DOCUMENT TRANSMITTAL 2003-55088

TRM1 - TECHNICAL REQUIREMENTS MANUAL UNIT 1

Susquehanna SES Unit 1 Cycle 13

CORE OPERATING LIMITS REPORT

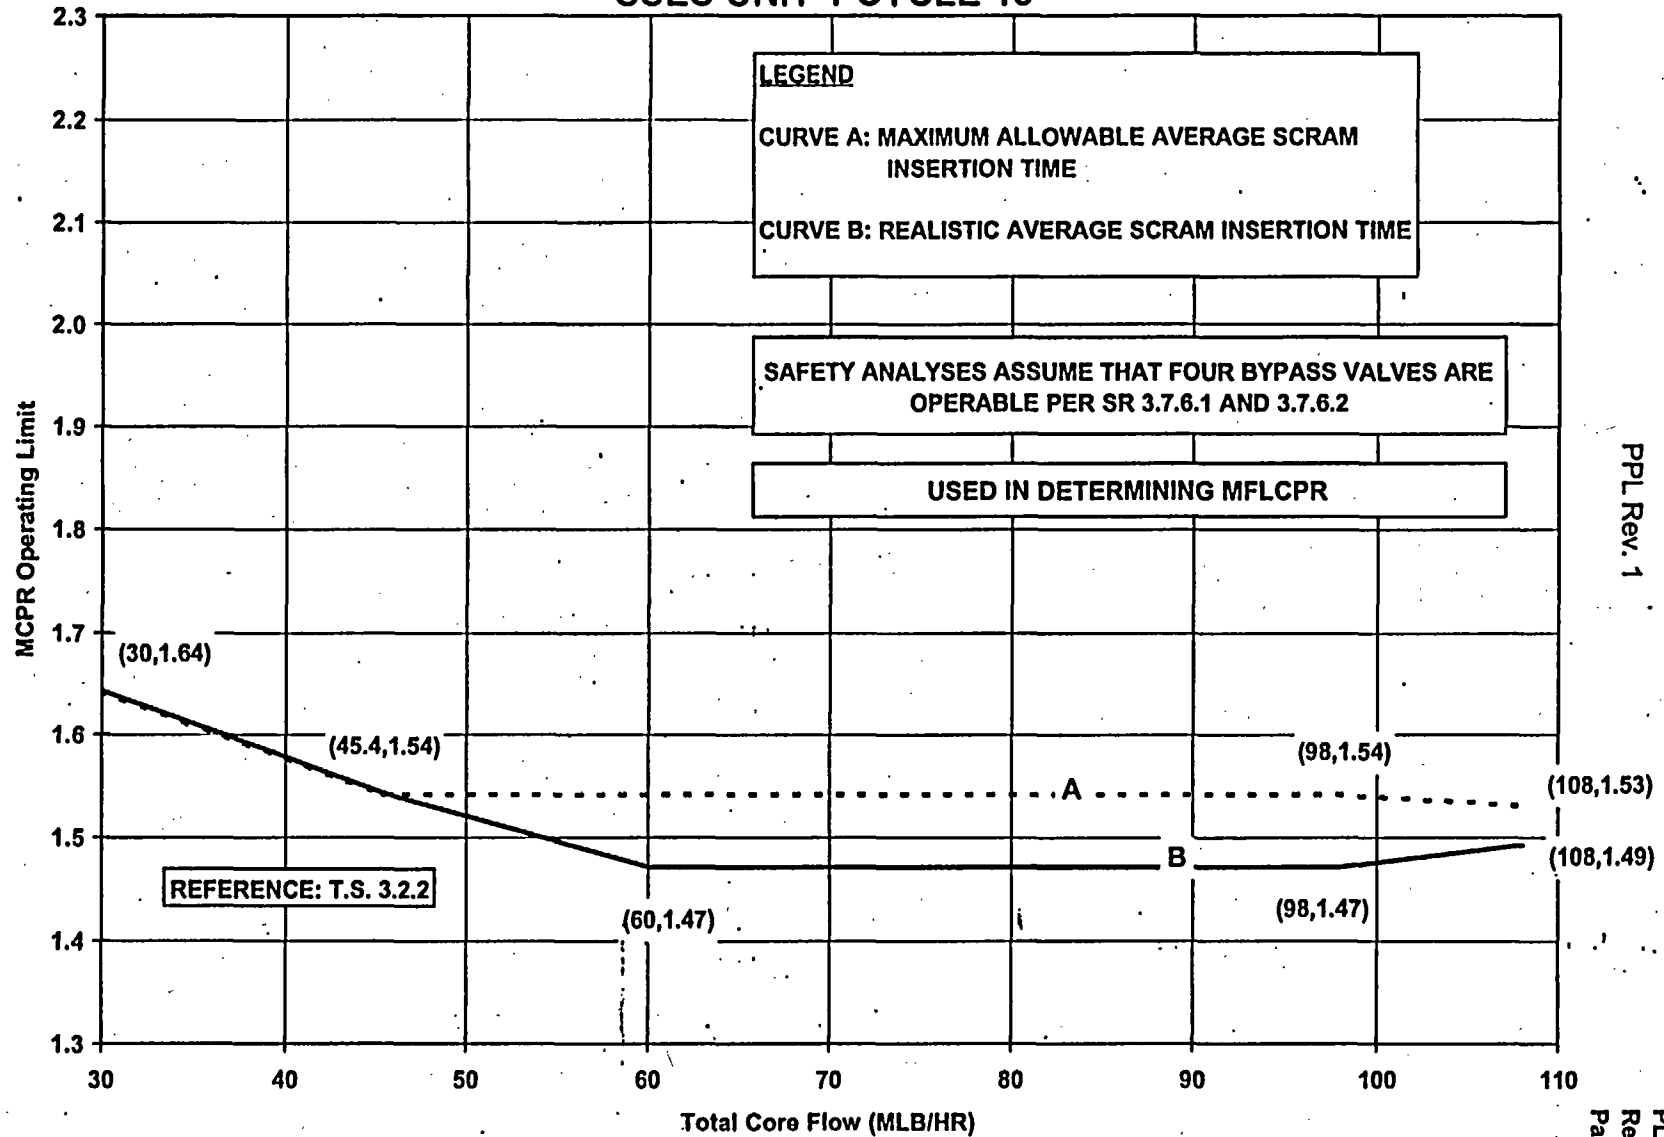
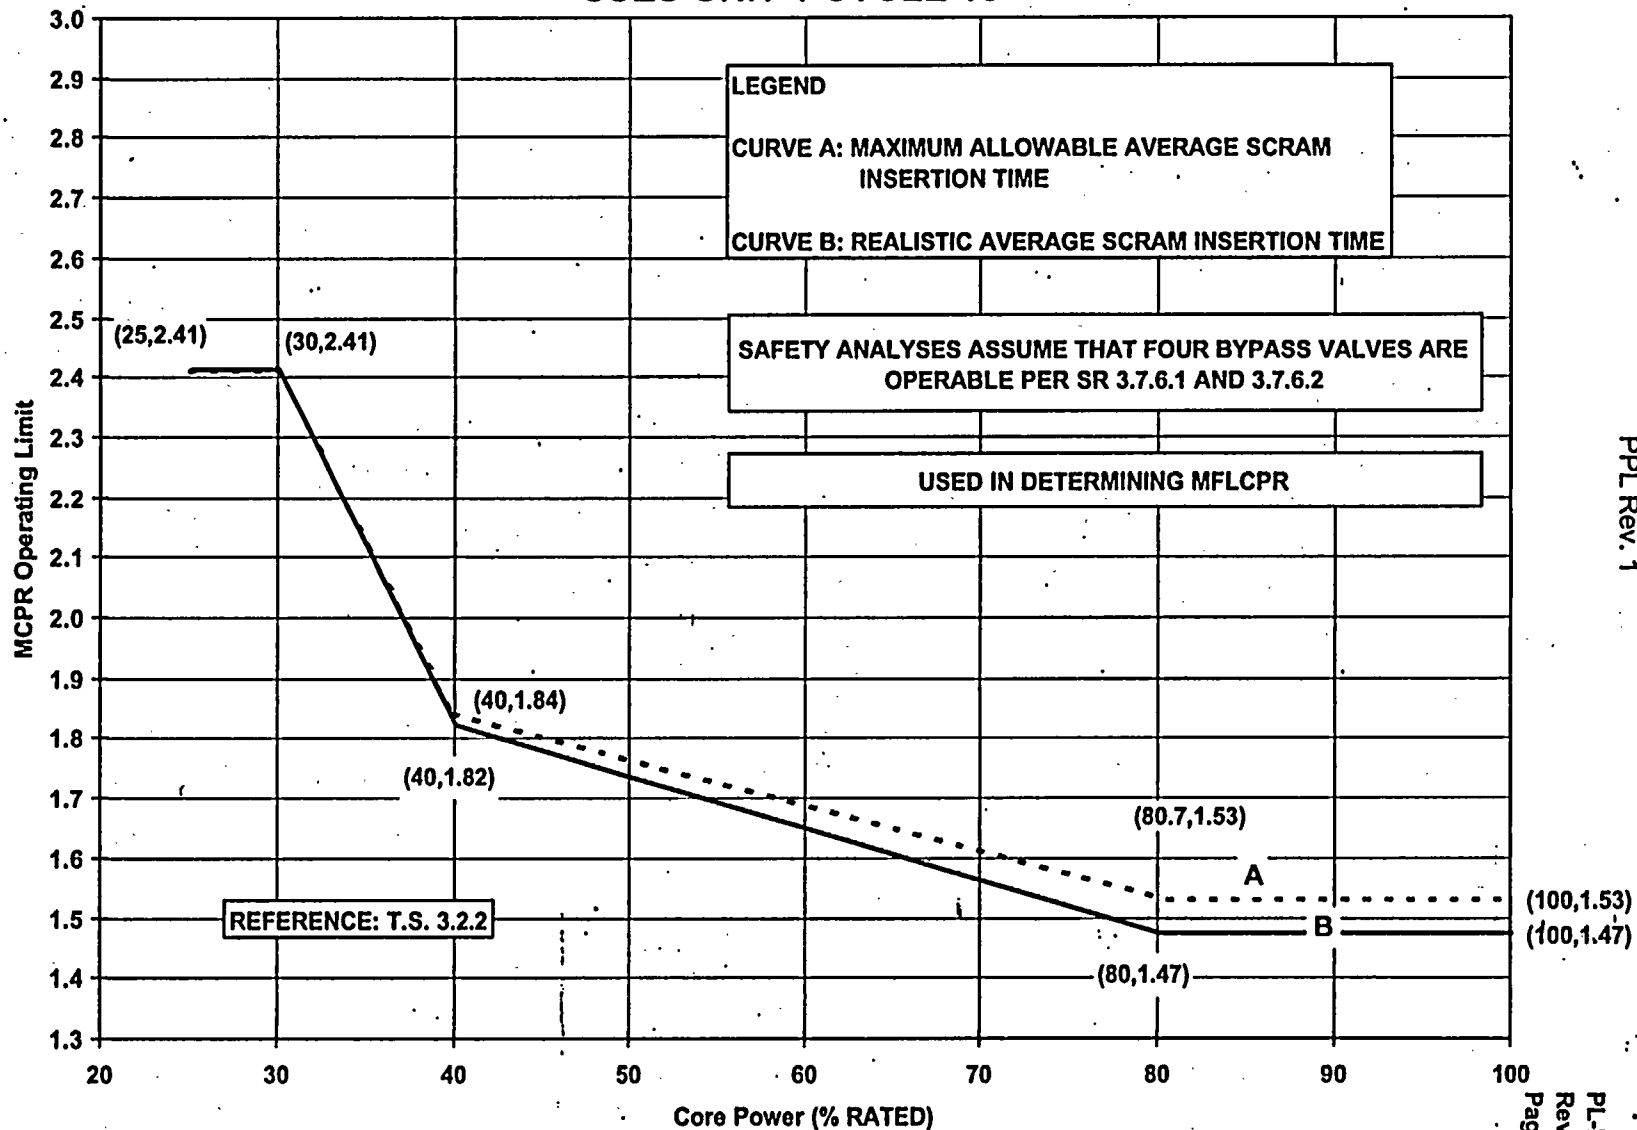
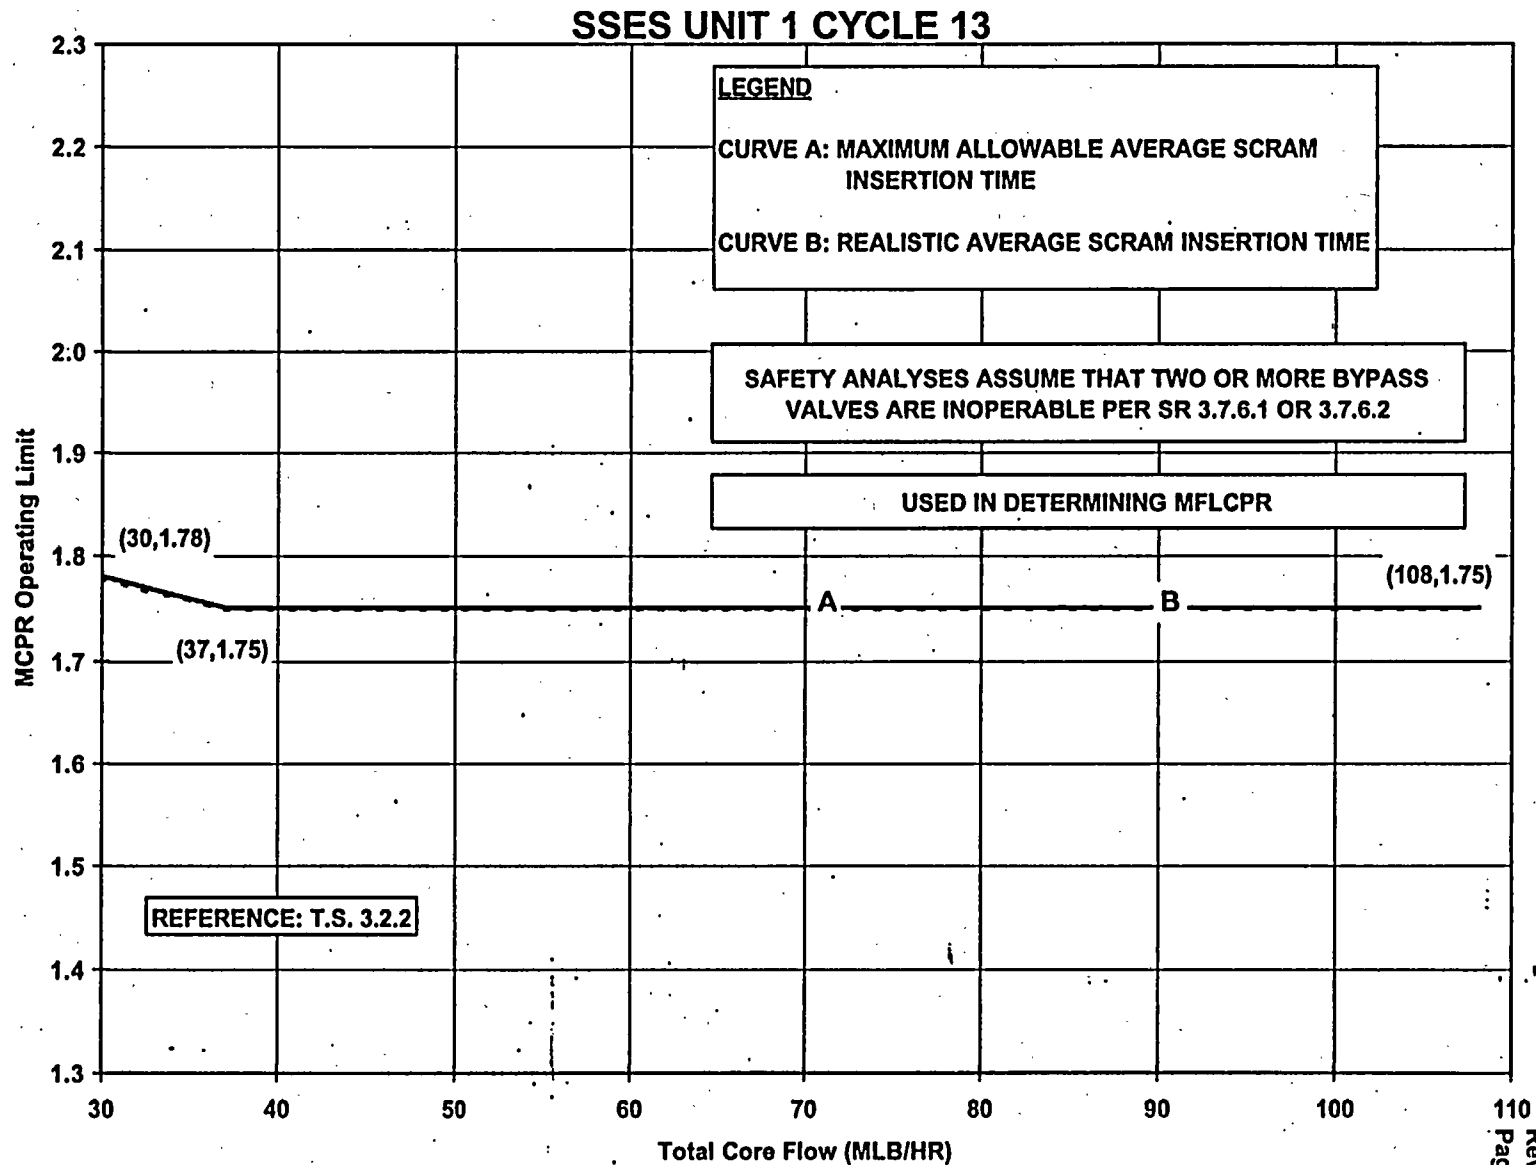
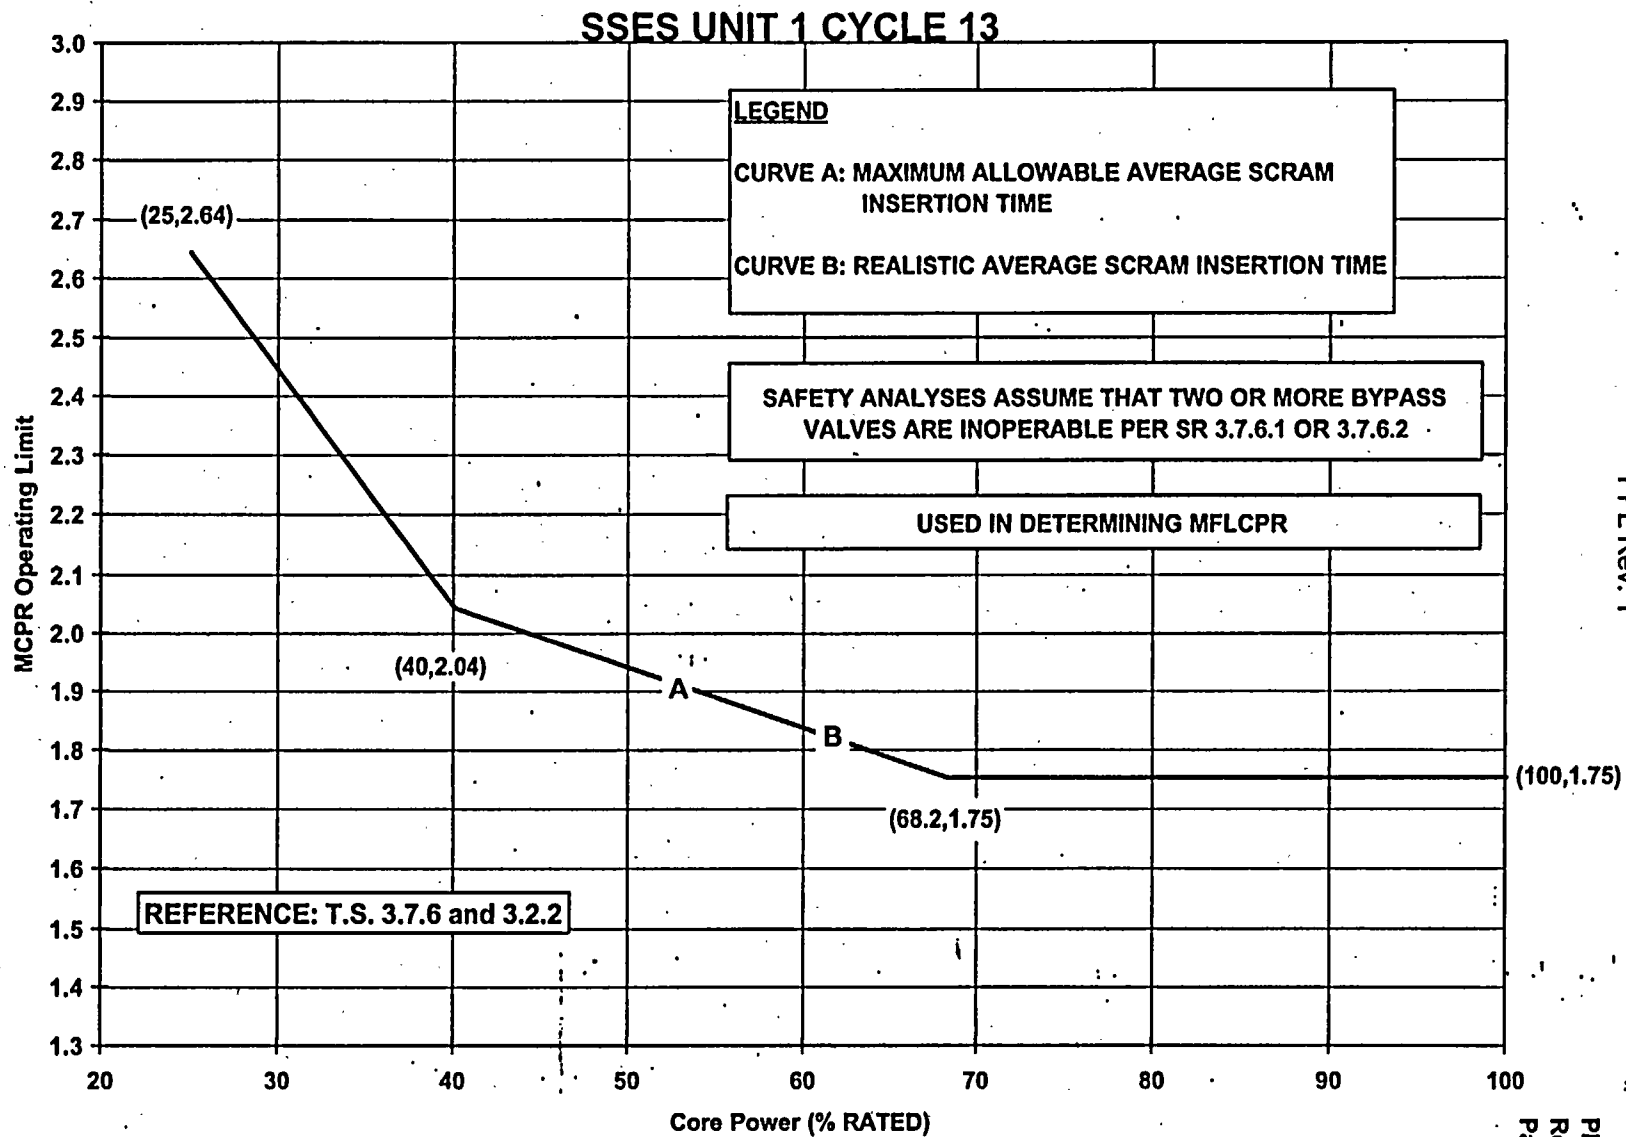
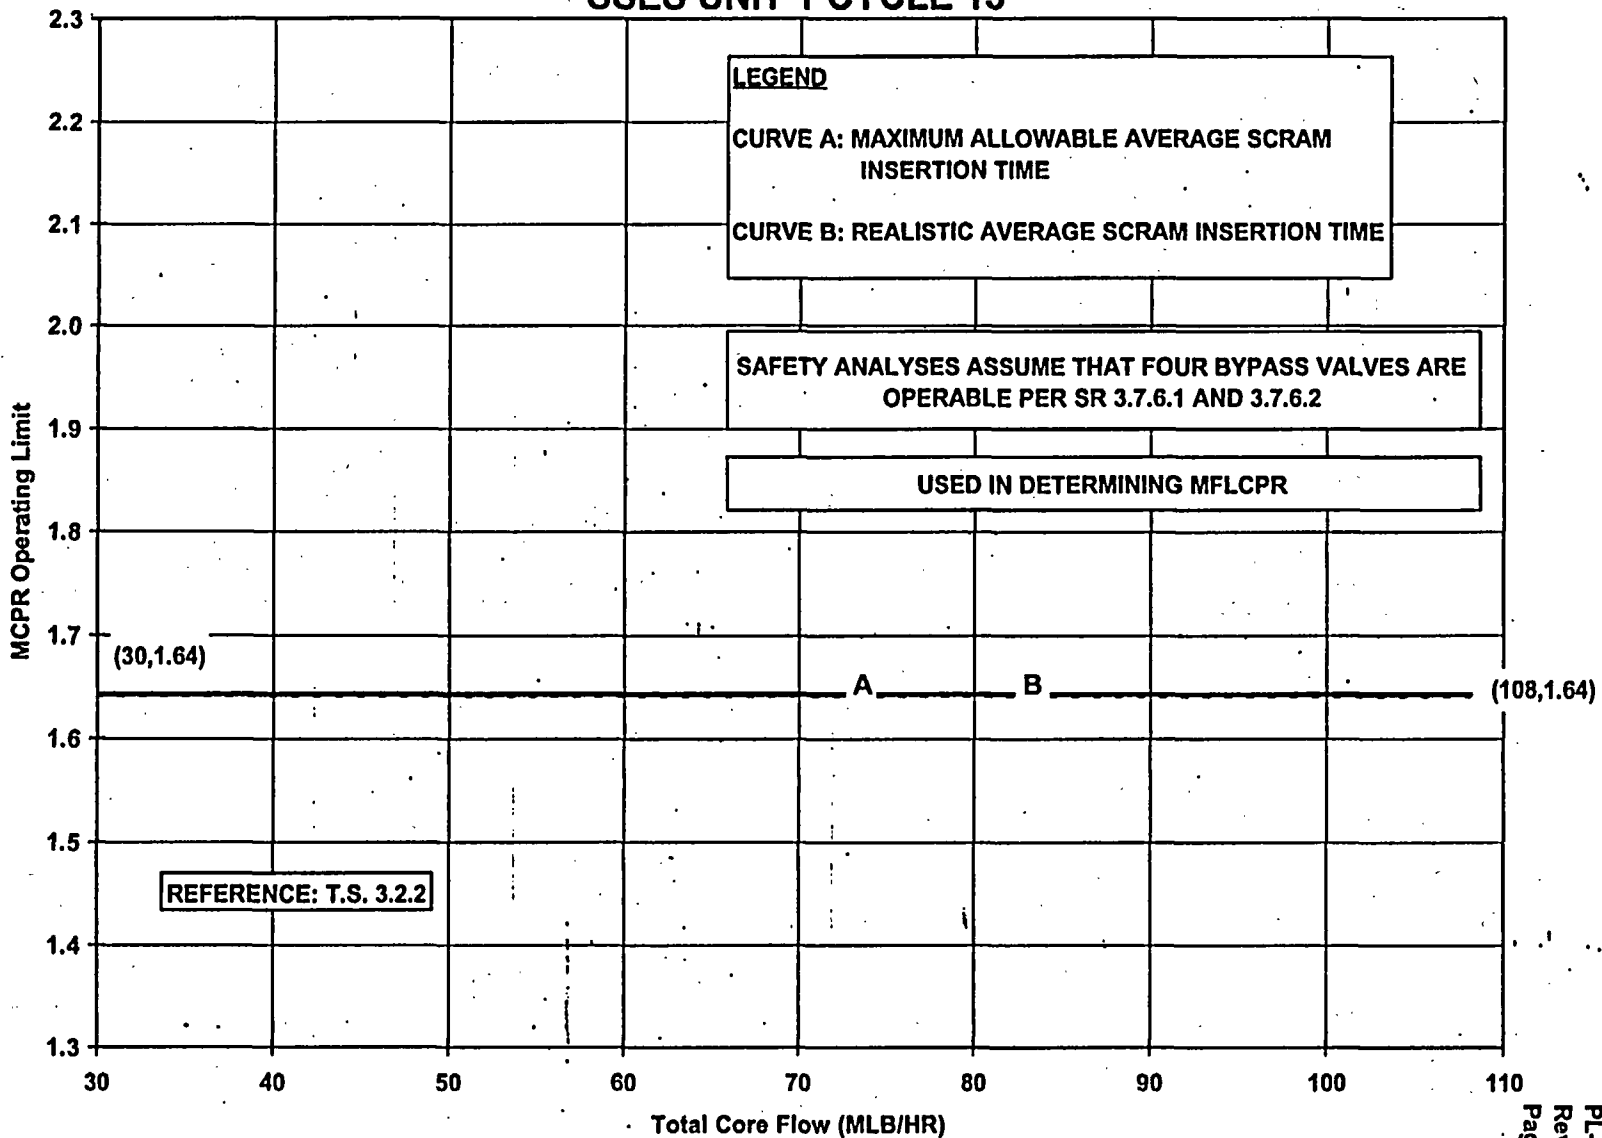
Rev. No.	Affected Sections	Description/Purpose of Revision
0	ALL	Issuance of this COLR is in support of Unit 1 Cycle 13 operation.
1	5.0 6.0 8.0	<p>This revision adds a text box to all appropriate plots. This text box indicates that for all bypass operable cases, four bypass valves are assumed operable. For the bypass inoperable cases, the text box indicates that two or more bypass valves are assumed inoperable.</p> <p>This revision was generated in response to Facility Operating License Amendment 210 which altered SR 3.7.6.1.</p> <p>This revision is administrative in nature and no underlying calculations or plotted data were altered.</p>
2	TOC 1.0 9.0 10.0	<p>This revision adds the Power / Flow map to the COLR. Section 1.0 was revised to include the stability regions as part of the COLR. The Power / Flow map was added as Section 9.0. The Reference section was renumbered as Section 10.0 and a stability reference added.</p> <p>This revision is administrative in nature since the Power / Flow map is already included in NDAP-QA-0338.</p>
